UNITED STATES
NUCLEAR REGULATORY COMMISSION
WASHINGTON, D.C. 20555-0001

BYRON STATION, UNIT NO. 1

AMENDMENT TO FACILITY OPERATING LICENSE

Amendment No. 77
License No. NPF-37

FIGURE 3.4-1
DOSE EQUIVALENT I-131 REACTOR COOLANT SPECIFIC ACTIVITY
LIMIT VERSUS PERCENT OF RATED THERMAL POWER WITH THE REACTOR
COOLANT SPECIFIC ACTIVITY >1μCi/GRAM DOSE EQUIVALENT I-131*

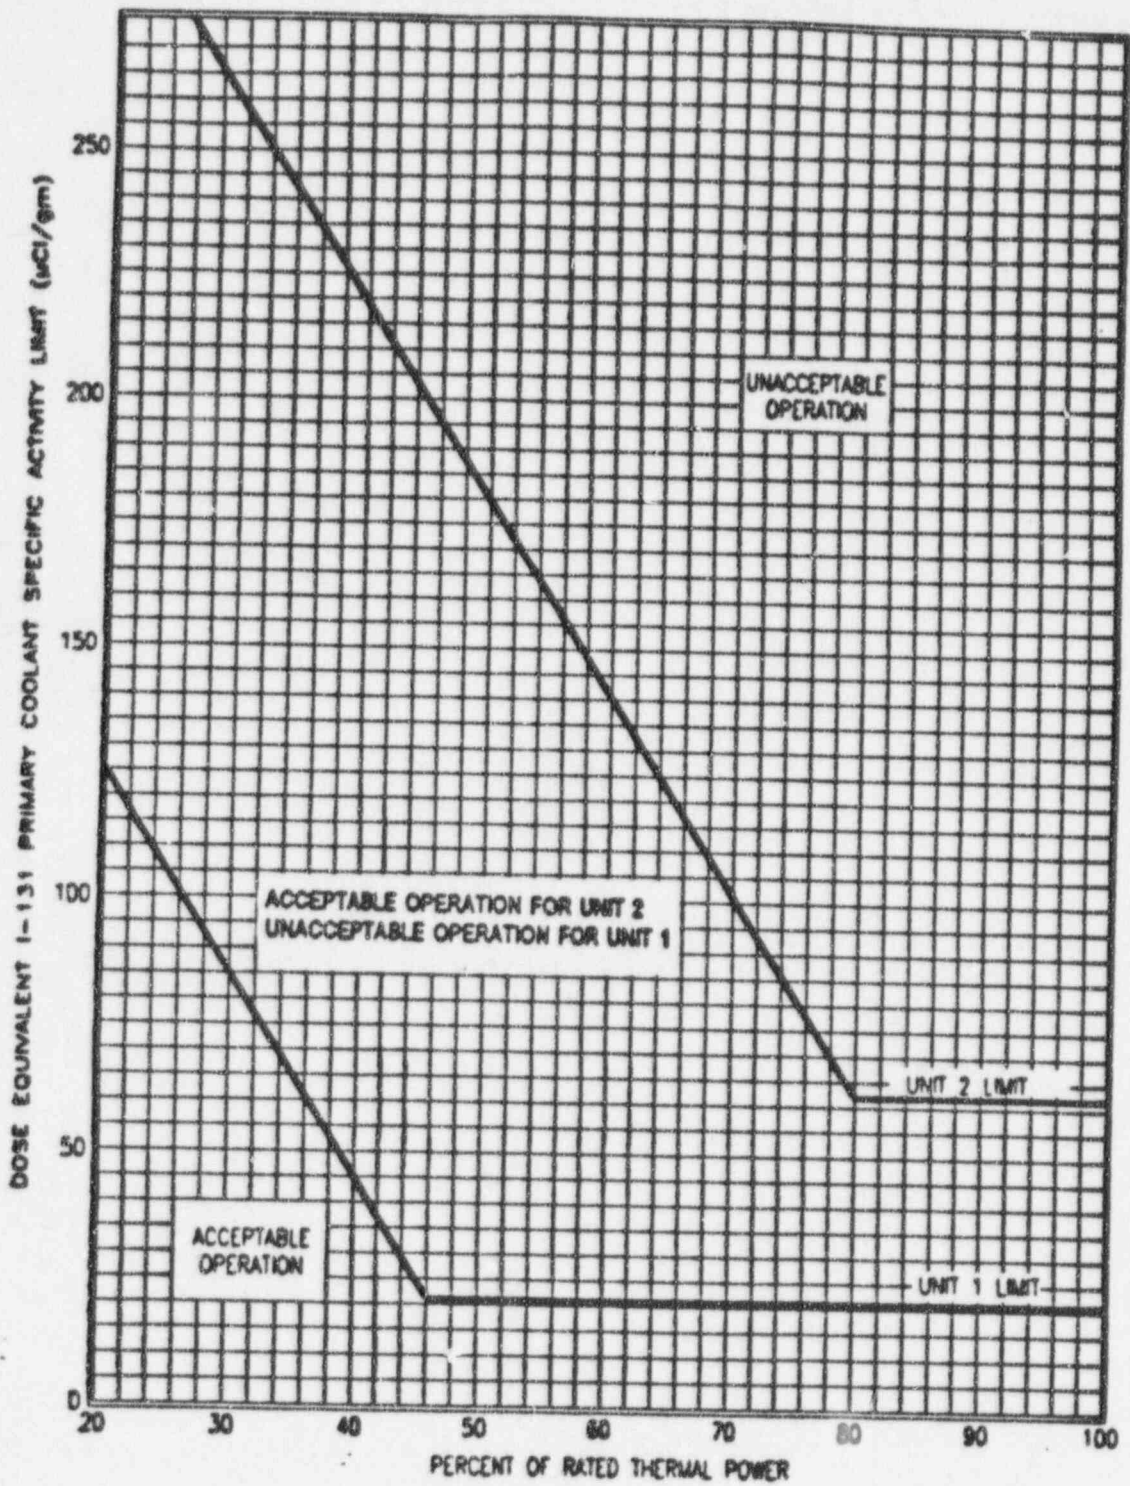
- a. With the specific activity of the reactor coolant greater than 1 microCurie per gram DOSE EQUIVALENT I-131** for more than 48 hours during one continuous time interval or exceeding the limit line shown on Figure 3.4-1, be in at least HOT STANDBY with T_{avg} less than 500°F within 6 hours; and
- b. With the specific activity of the reactor coolant greater than $100/\bar{E}$ microCuries per gram, be in at least HOT STANDBY with T_{avg} less than 500°F within 6 hours.

**For Unit 1, reactor coolant DOSE EQUIVALENT I-131 will be limited to 0.35 microCuries per gram.

*For Unit 1, Reactor Coolant Specific Activity >0.35 μCi/Gram DOSE EQUIVALENT I-131

FIGURE 3.4-1
DOSE EQUIVALENT I-131 REACTOR COOLANT SPECIFIC ACTIVITY
LIMIT VERSUS PERCENT OF RATED THERMAL POWER WITH THE REACTOR
COOLANT SPECIFIC ACTIVITY $>1\mu\text{Ci}/\text{GRAM}$ DOSE EQUIVALENT I-131*

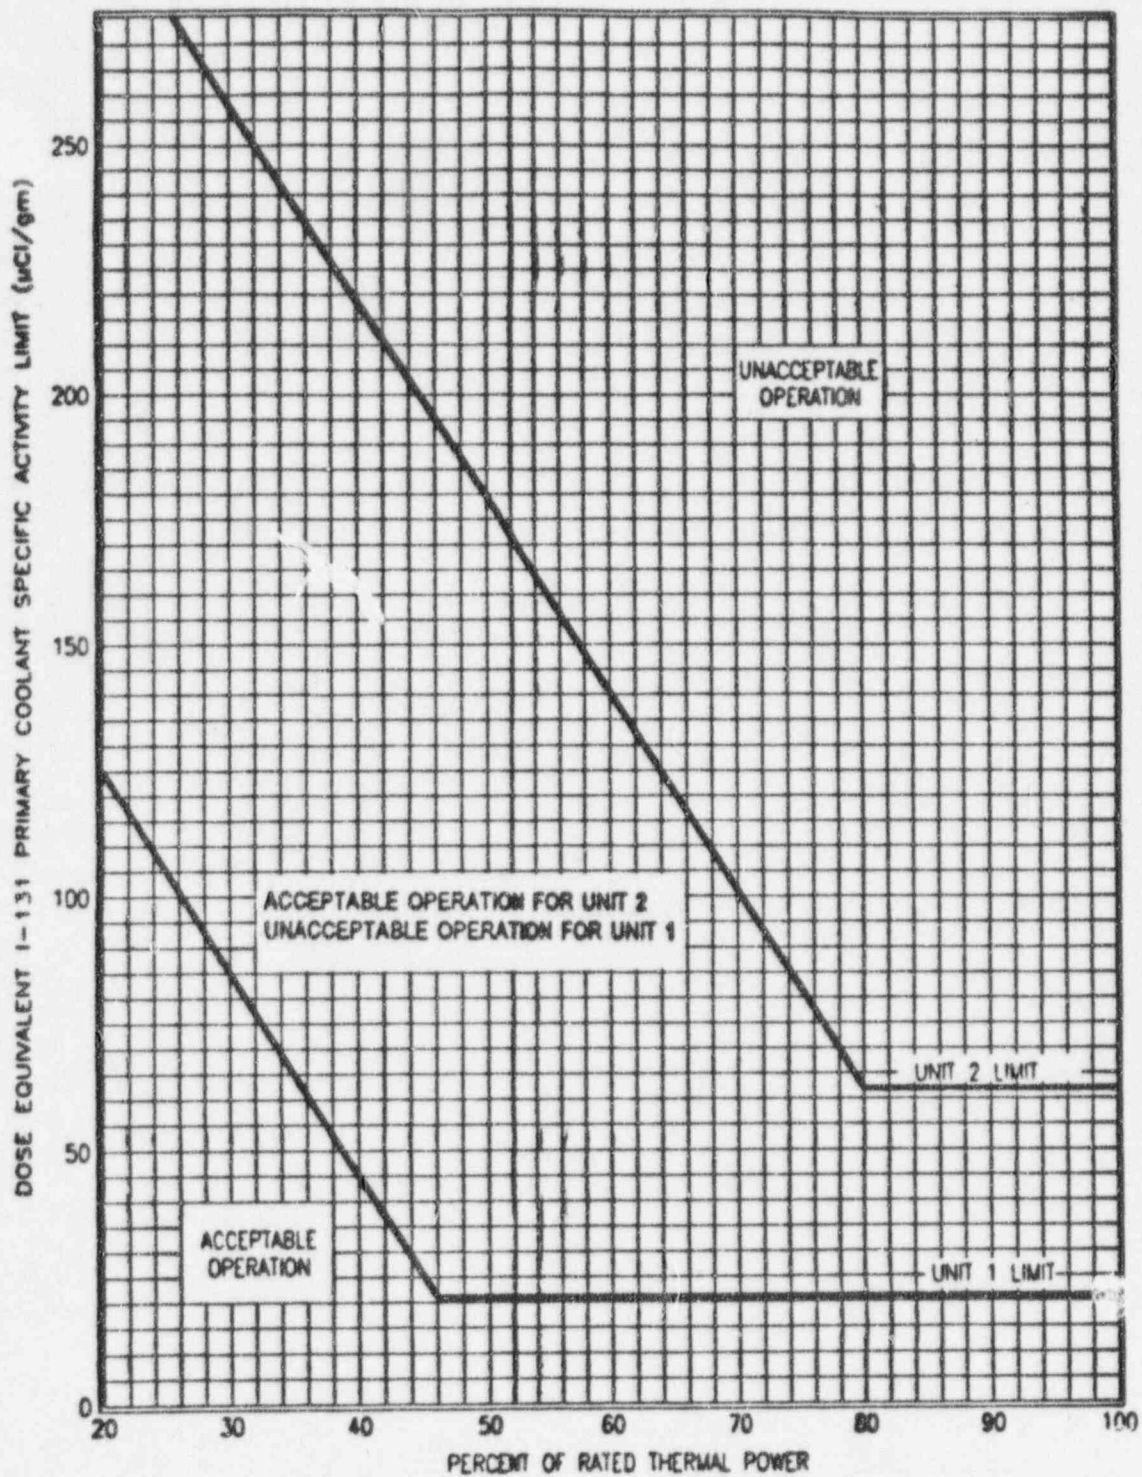
- a. With the specific activity of the reactor coolant greater than 1 microCurie per gram DOSE EQUIVALENT I-131** for more than 48 hours during one continuous time interval or exceeding the limit line shown on Figure 3.4-1, be in at least HOT STANDBY with T_{avg} less than 500°F within 6 hours; and
- b. With the specific activity of the reactor coolant greater than $100/\bar{E}$ microCuries per gram, be in at least HOT STANDBY with T_{avg} less than 500°F within 6 hours.

*For Unit 1, reactor coolant DOSE EQUIVALENT I-131 will be limited to 0.35 microCuries per gram.

*For Unit 1, Reactor Coolant Specific Activity $>0.35\ \mu\text{Ci}/\text{Gram}$ DOSE EQUIVALENT I-131
